FORM APPROVED
OMB NO. 1004-0137
Expires: January 31, 2018**SUNDRY NOTICES AND REPORTS ON WELLS**
Do not use this form for proposals to drill or to re-enter an
abandoned well. Use form 3160-3 (APD) for such proposals.

MARATHON OIL - FLETCHER A DE FED 2 - API: 30-025-02468 - LEA COUNTY

Permanent Abandonment of Federal Wells
Conditions of Approval (LPC Habitat)

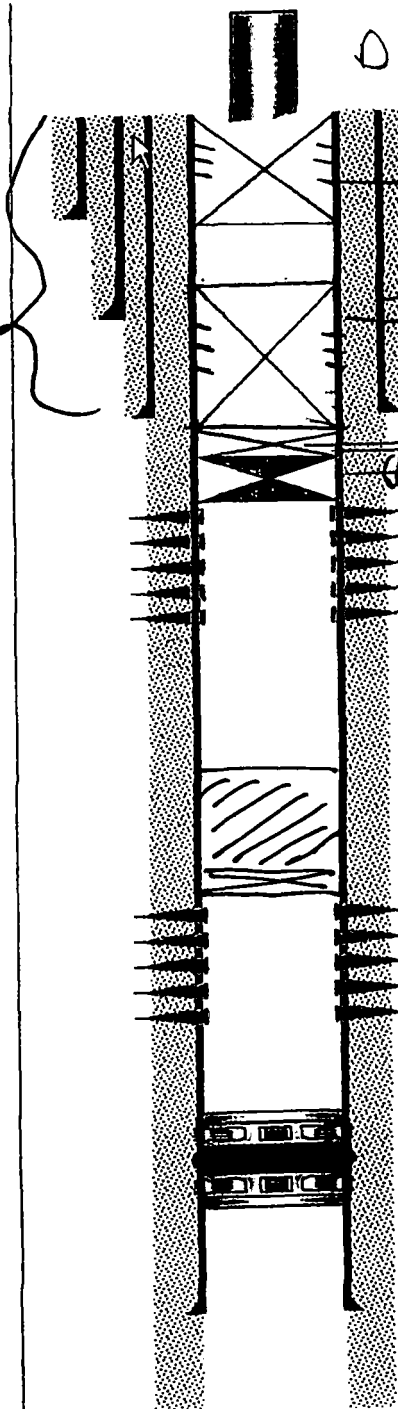
④ 70 SX @ 100' - Surf P.S. Visually Verifying

3459 cap w/ 35 SX

Casing & Logs
Not Matching
Record.

7" CIBP @ 3459. Spot emt (R 111 A Solid Plug)
from 3459 - 1547. WOC Tag
Spot emt from 413 - Surf.
